Architectural Review Board Staff Report

Project Type: Amended Architectural Elevations

Description: **Chesterfield Commons, Lot 112 (Verizon) AAE:** Amended Architectural Elevations and Architect's Statement of Design for a 1.89 acre tract of land zoned "C-8" Planned Commercial District located on the south side of Chesterfield Airport Rd., east of First Community Dr.

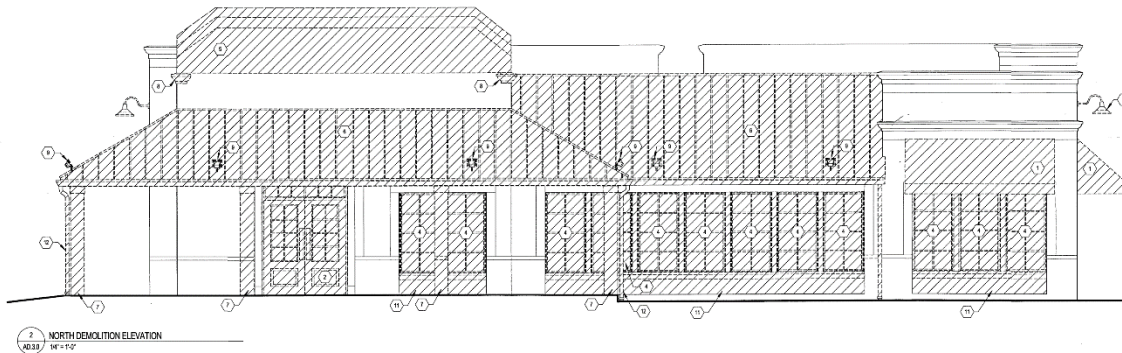
Changes to scale include removal of the existing metal roof and portion of the expanded entrance and matching the parapet height on the remainder of the building.

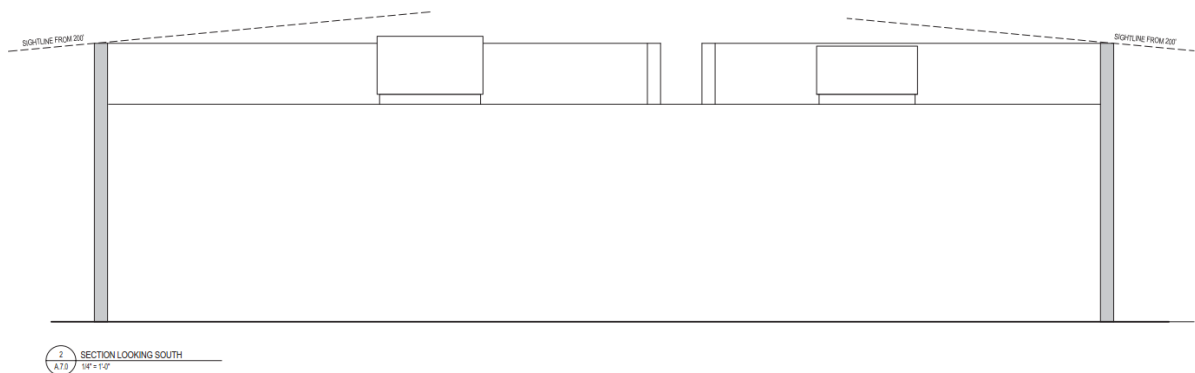
A new black metal canopy will replace the existing red metal roof. Existing columns associated with the entrance will be removed.

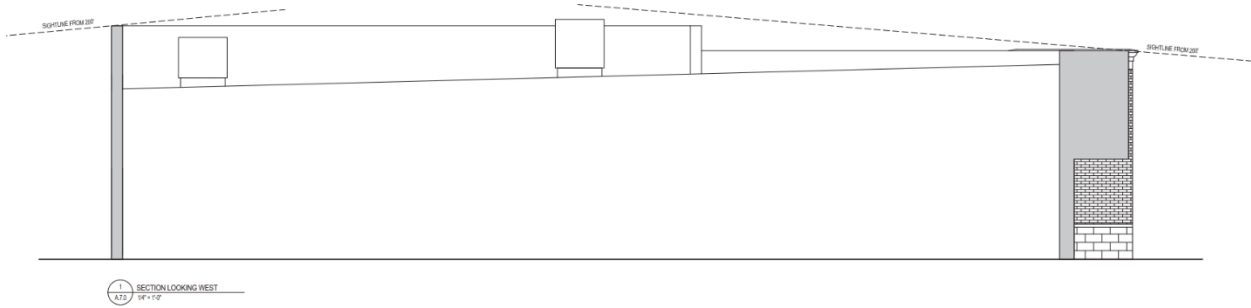
The new canopy will be a black metal canopy. The proposal also includes replacing existing windows and storefront with a new system. All other materials and colors will remain unchanged.
